# Bid Addendum

## Addendum No.: 3

Project Name: Harnett Street Stormwater Improvements

1. Requests for Information
  - a. See attached document
2. Changes to the Project Manual
  - a. Bid form
3. Changes to the Construction Documents
  - a. C51, C52, C53, C54

C54

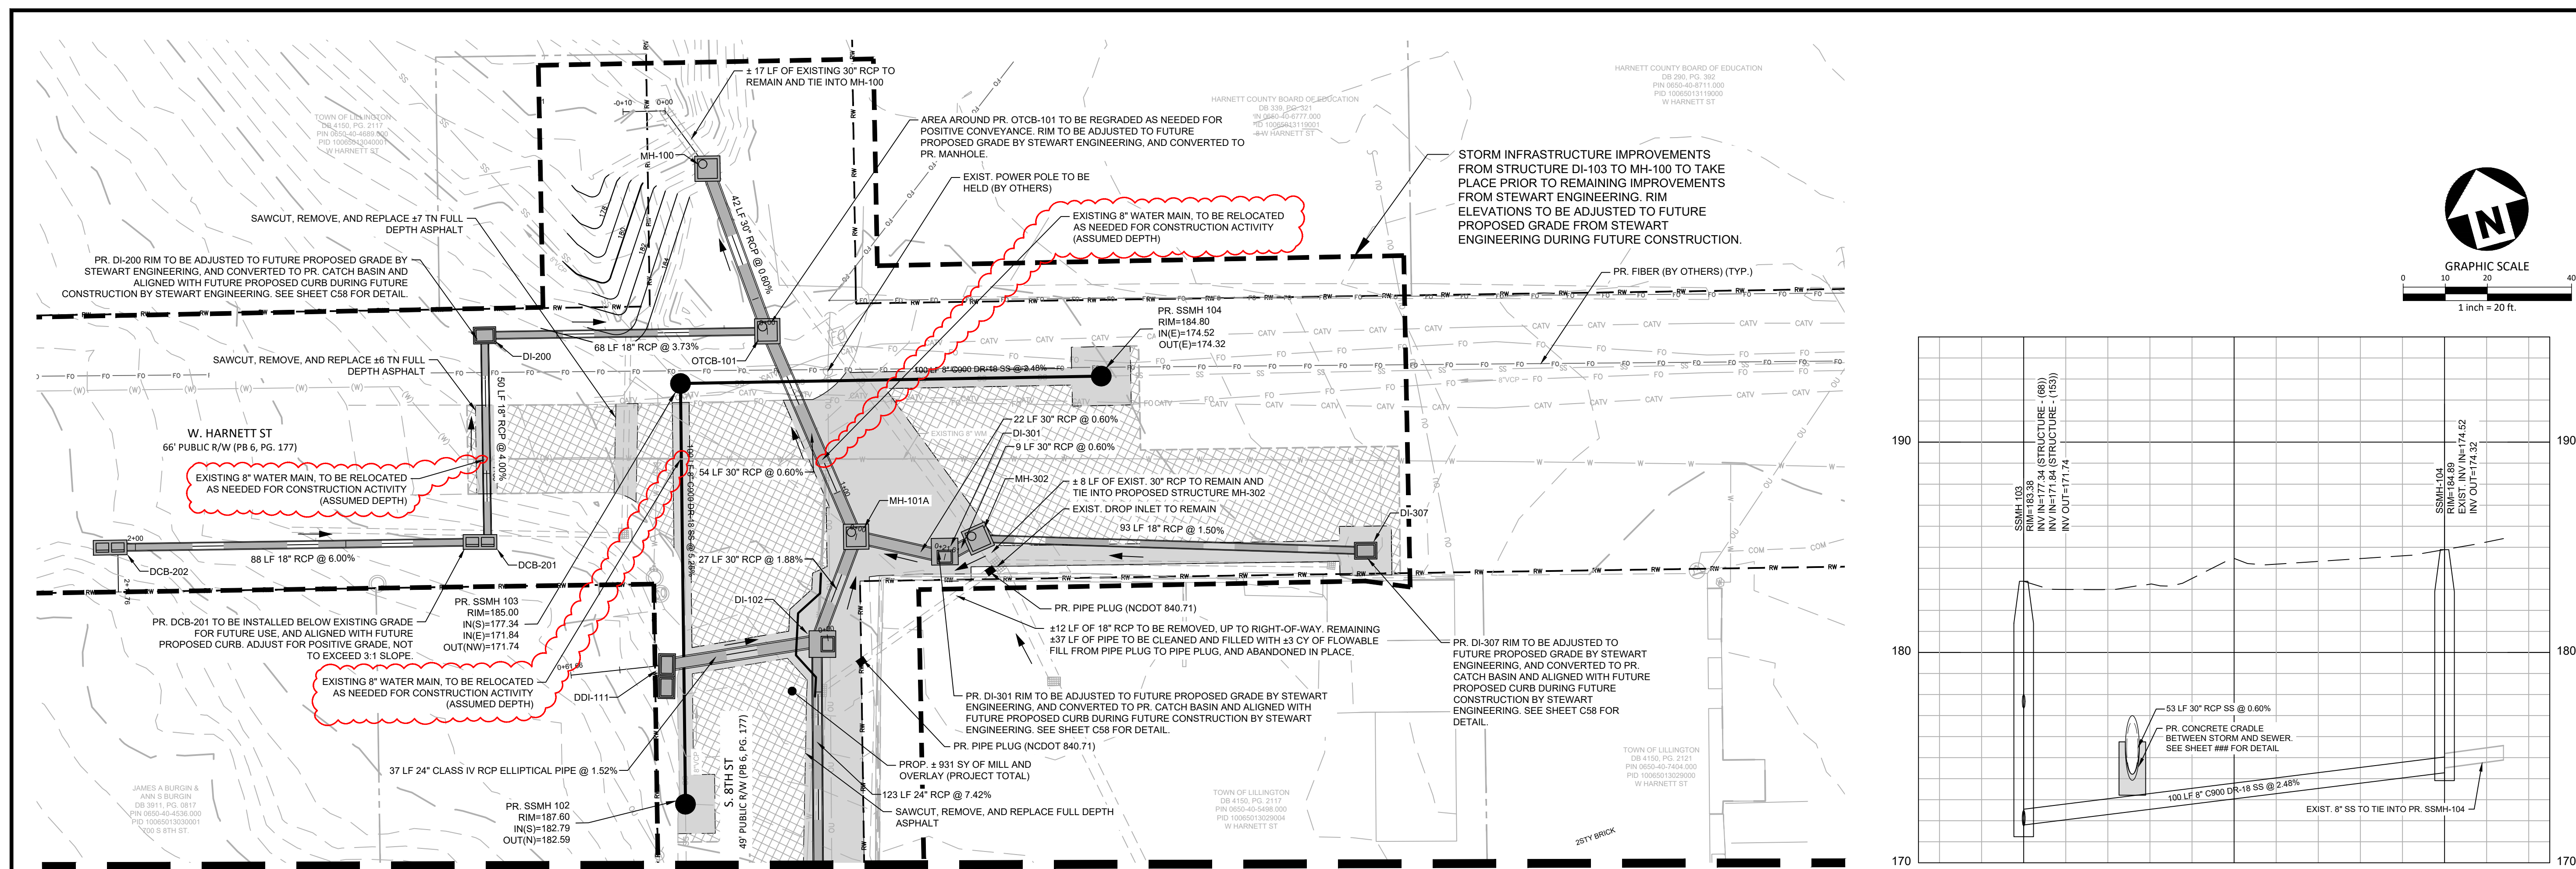
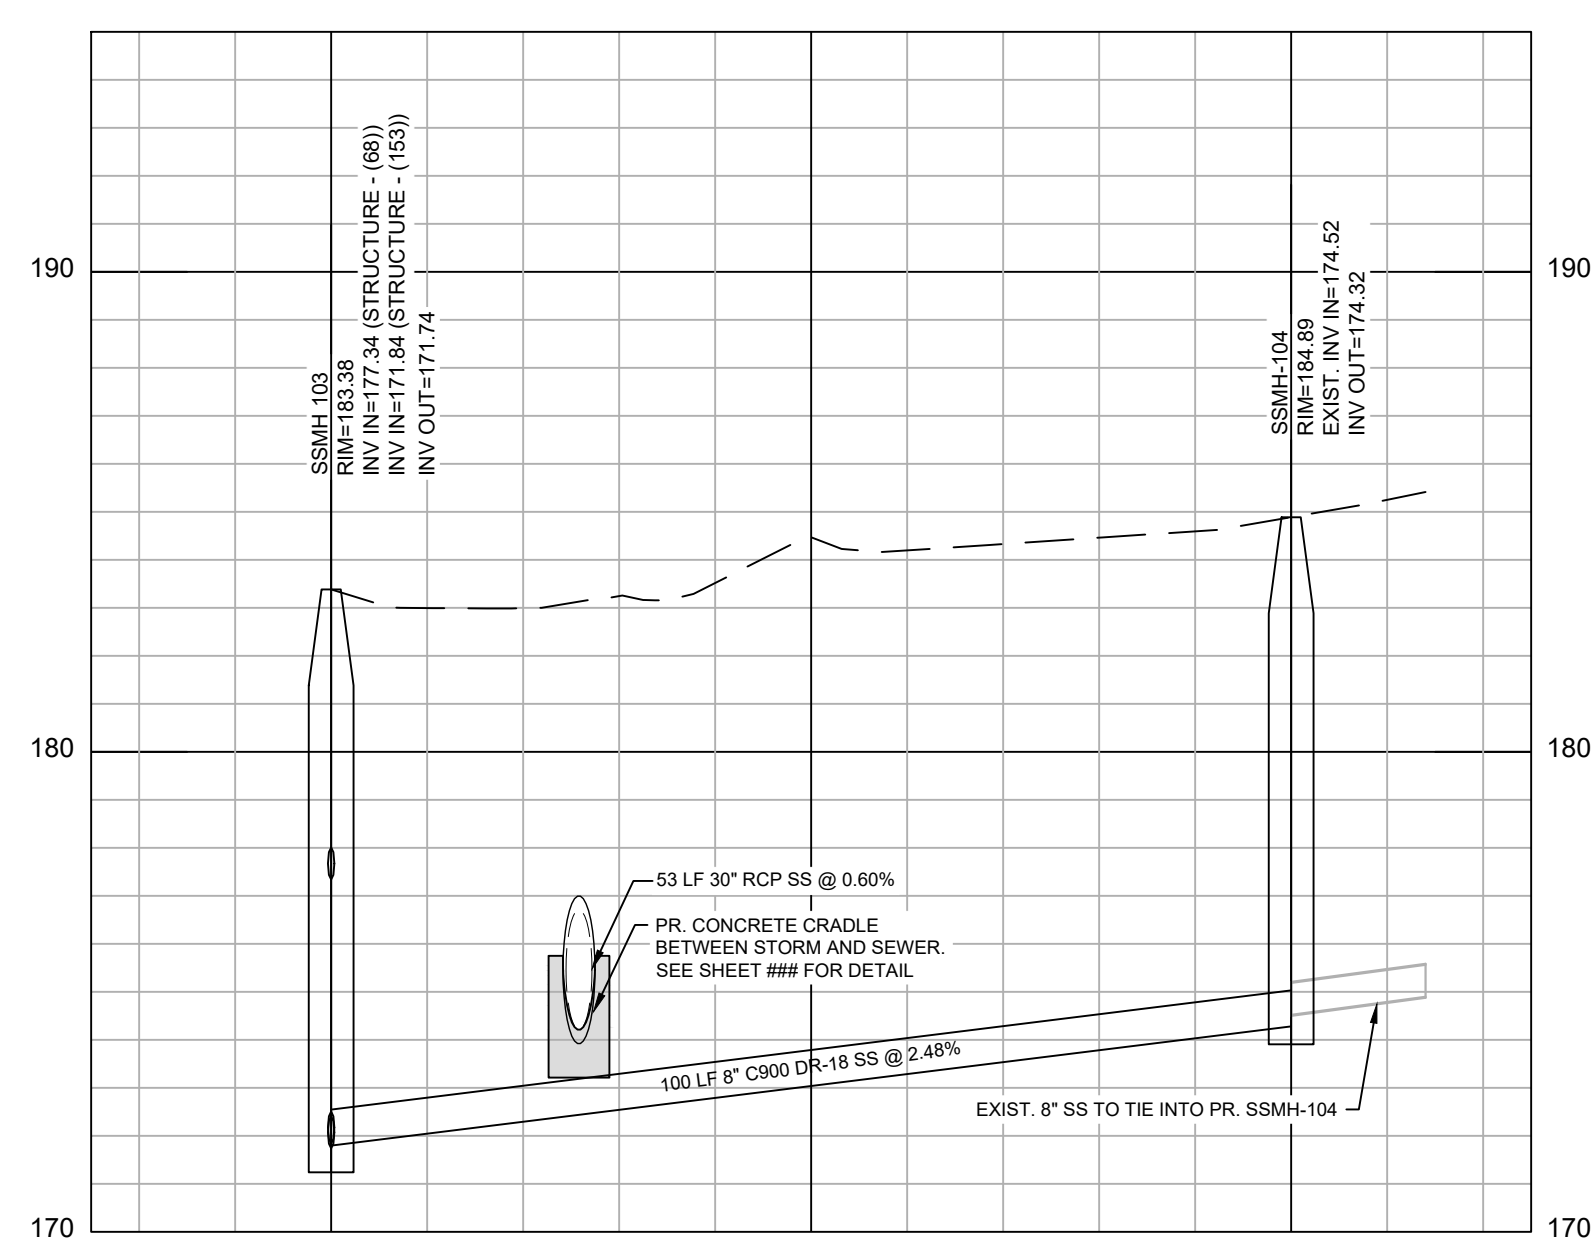
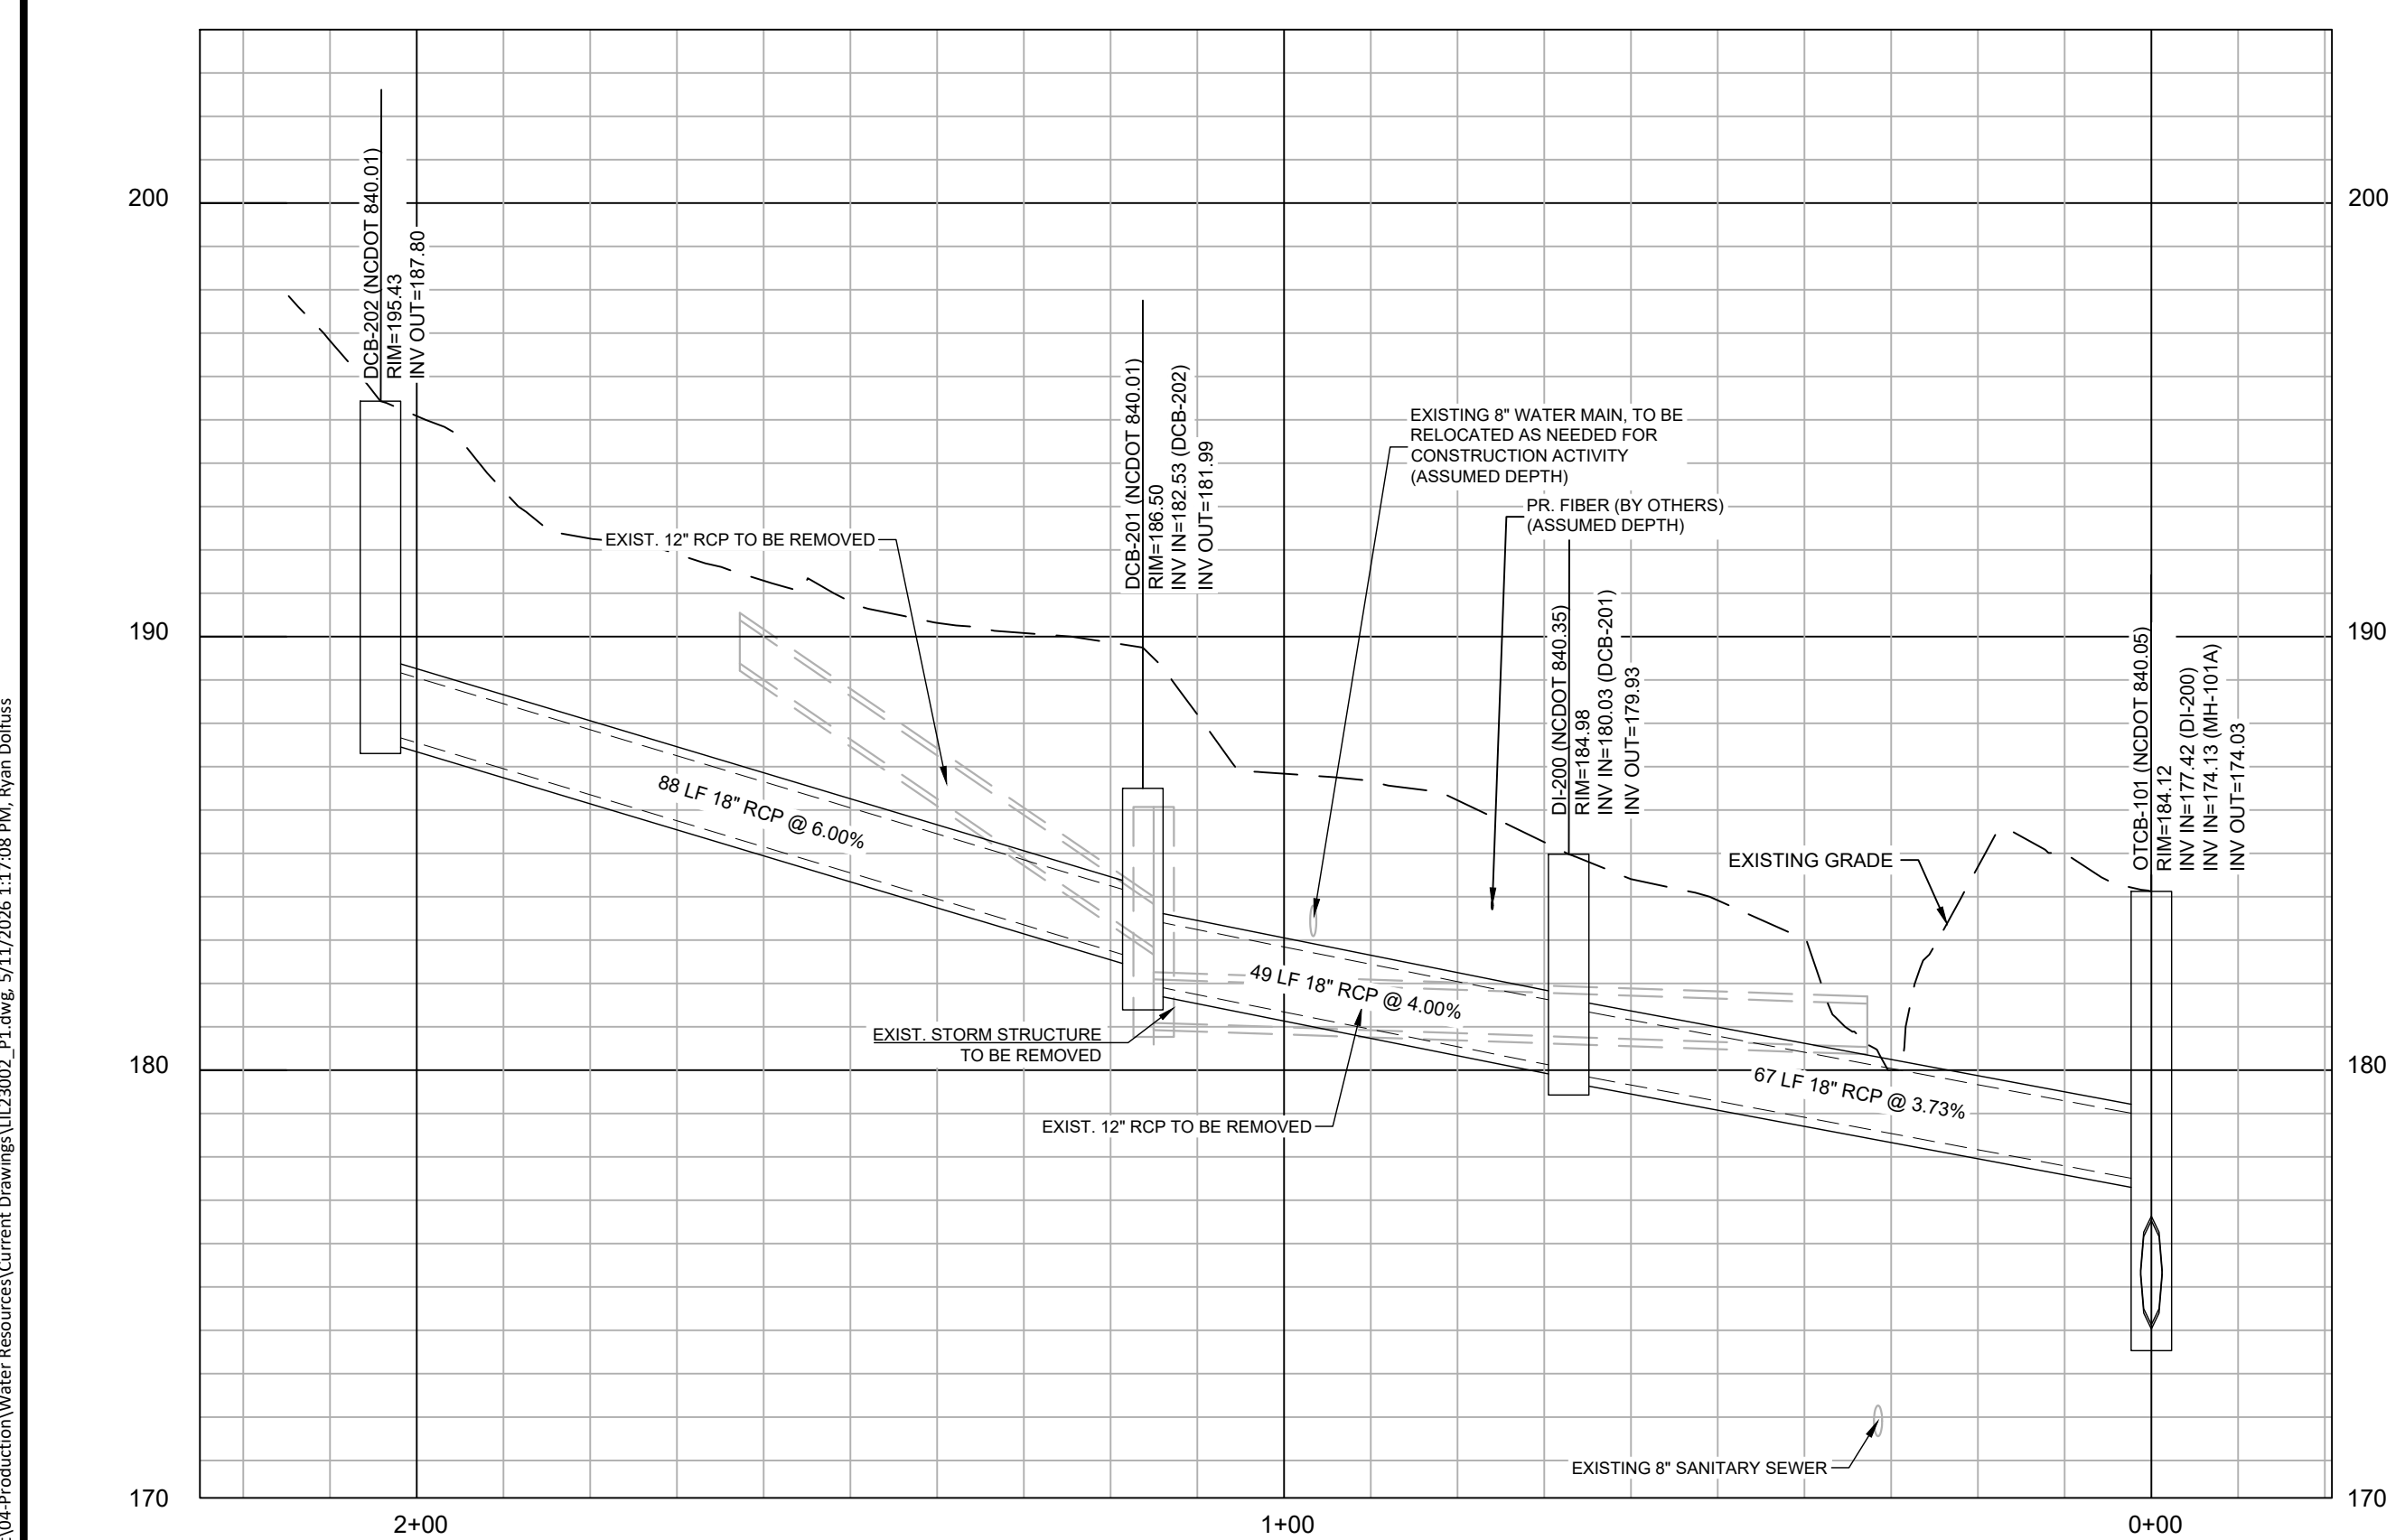
8. Are there waterline plans that correspond to the waterline bid items on the McAdams bid form? Only 6" Waterline relocations are shown on the plans.

**Engineer Response: There are 6" waterlines that are being relocated horizontally, shown in plan view in the construction documents (Sheets C51, C52, C54). There are also vertical relocations due to unknown watermain depths, which account for the additional 4" and 8" waterline bid items (A-41, A-43). These horizontal and vertical relocations are reflected in profile view in the construction documents (see attached Sheets C51, C52, C53, C54).**
